Access Compliance Report

Public Rights-of-Way

(Curb Ramps)

Intersection ID: 17737	Main Street: ADDISON_DR	Cross Street: N_SHARON_AMITY_RD	Location: SW
ADA ID: 0EB65427BA90	Ramp Type: PerpDiag	Initial Pass/Fail: Fail	Overall Compliance: No
Severity Score: 33.75			
Codes/Mitigation Info/Possible Solution		Field Measurements/Component Compliance

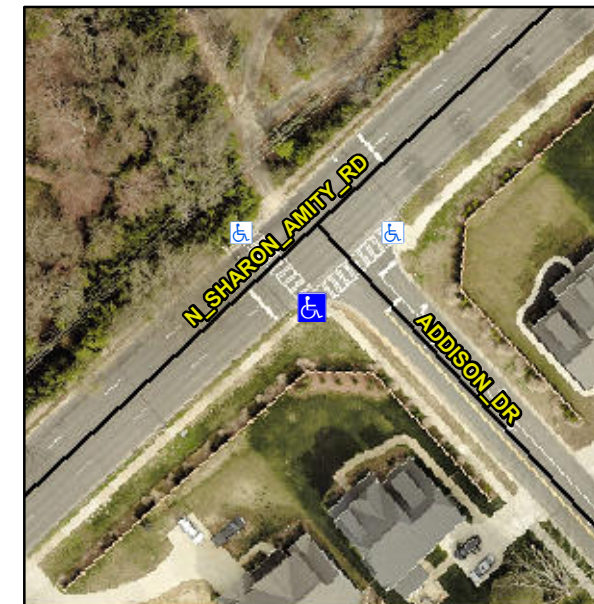
Not Found, R304.5.1, R304.5.3

Compliance	Description	Data	Compliance	Description	Data
N/A	Ramp Length (in)	83.0	Yes	Ramp Slope (%)	6.5
No	Ramp Width (in)	36.0	No	Ramp XSlope (%)	7.7
N/A	Flare Type LT	N/A	N/A	Flare Type RT	N/A
N/A	Flare Slope LT (%)	N/A	N/A	Flare Slope RT (%)	N/A
N/A	Flare Traversable LT?	N/A	N/A	Flare Traversable RT?	N/A
N/A	Landing Length (in)	N/A	N/A	DWS Provided?	N/A
N/A	Landing Width (in)	N/A	N/A	DWS Contrast?	N/A
N/A	Landing Slope (%)	N/A	N/A	DWS Length (in)	N/A
N/A	Landing X Slope (%)	N/A	N/A	DWS Full Width?	N/A
N/A	Landing Curb? (Y/N)	N/A	N/A	DWS Offset (in)	N/A
N/A	Shared Landing?	N/A			
N/A	Gutter Ponding?	N/A	N/A	Gutter Slope (%)	N/A
N/A	Gutter Lip Ht (in)	N/A	N/A	Gutter X Slope (%)	N/A
N/A	Painted X Walk1?	Yes	N/A	Painted X Walk2?	Yes
	X Walk 1 Direction	To NE		X Walk 2 Direction	To NW
N/A	X Walk 1 Width (in)	108.0	N/A	X Walk 2 Width (in)	110.0
	X Walk 1 Slope (%)	4.5		X Walk 2 Slope (%)	1.1
	X Walk 1 X Slope (%)	5.9		X Walk 2 X Slope (%)	5.9

Remove & Replace Curb Ramp With Two New Directional Ramps or Equivalent.
